BMP NUMBER: CC022

General File ID or BMP ID: CC022
PIN: 3911200001B
Owner Name: JAMES CITY COUNTY
Legal Description: COMMON OPEN SPACE P-1 IRONBOUND VILLAGE
Local Address: 5335 PALMER LANE

Re: Ironbound Village Subdivision and Site Plan
Case Nos. S-36-01 and SP-29-01
LMDG Job No. 2001112-000.07

ENVIRONMENTAL DIVISION REVIEW COMMENTS
IRONBOUND VILLAGE PHASE I (23 Lots)
COUNTY PLAN NO. S - 36 - 01
April 25, 2001

100yr routing

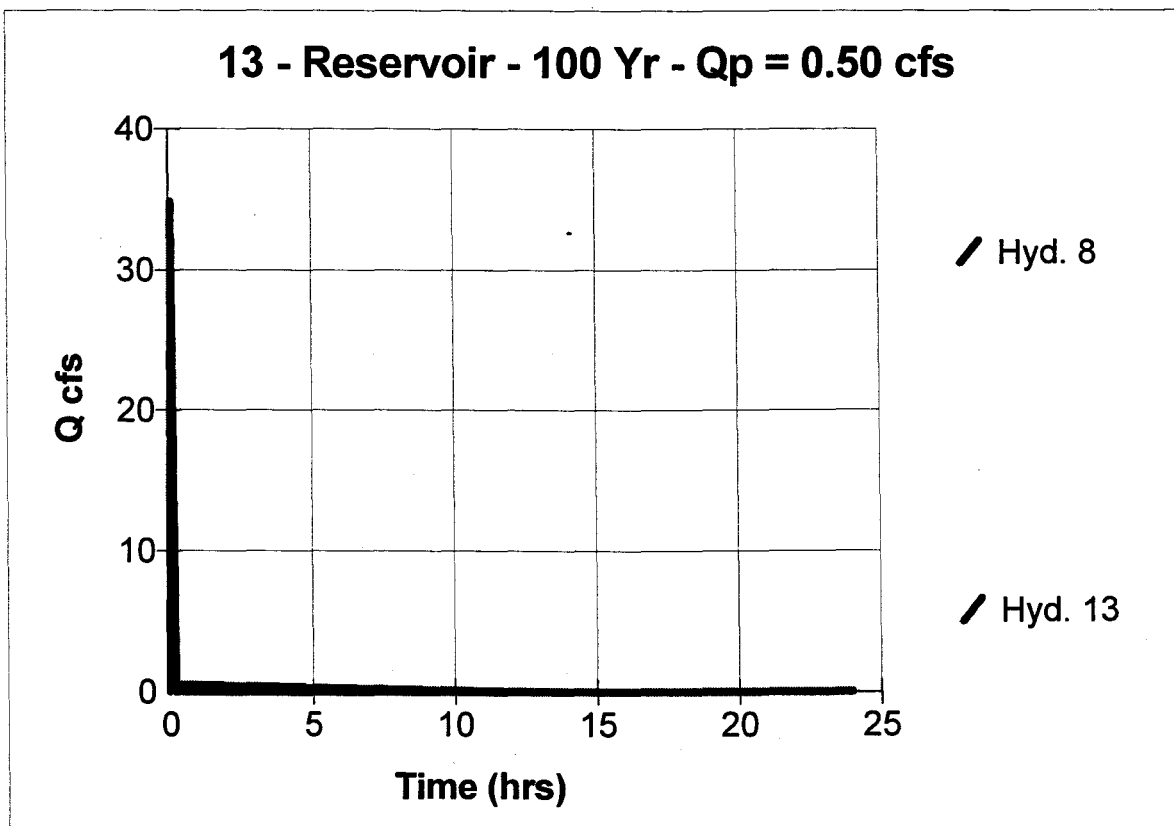
"BMP Design. Although no distinct discrepancies could be found in the pond's hydraulic report, please check connectivity in the hydraulic computer model for the basin. It is questionable, considering the small size of the basin and the relatively small peak outflow design discharges, that the water surface elevation for the 10- and 100-year storm events would not reach or go above the riser crest set at El. 77.0."

*Never reaches
riser crest @
EL 77.0*

CHANNEL GEOMETRY (SS #8)

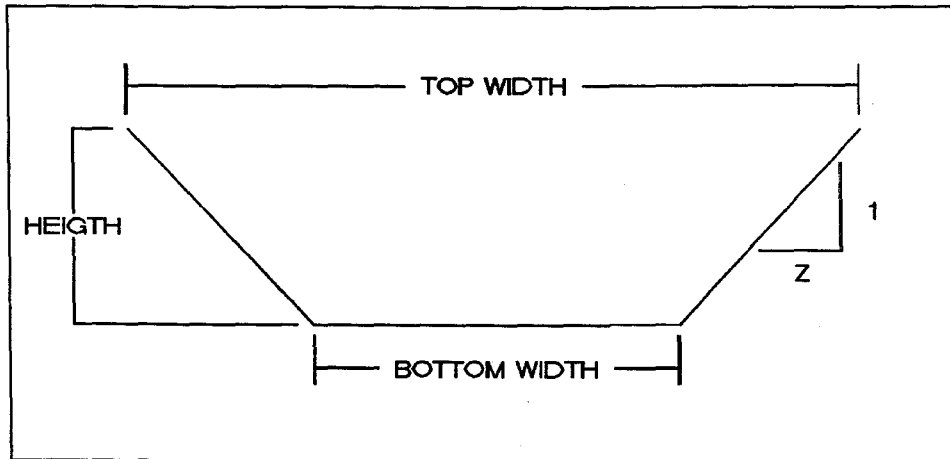
20. Stormwater Conveyance Channels. Label the dot-dashed line (ditch centerline) going to storm drain structures SS # 8, SS # 6B and SS # 12 appropriately as stormwater conveyance channels. Provide supporting design computations and a typical section or construction information as appropriate for these three onsite channels. Include slope, channel configuration, side slopes, lining, etc.

* INCREMENTAL DEPTH FOR POST DEVELOPMENT 10-YEAR
STORM IS LESS THAN THE HEIGHT OF THE CHANNEL,
THEREFORE, CHANNEL IS ADEQUATE.
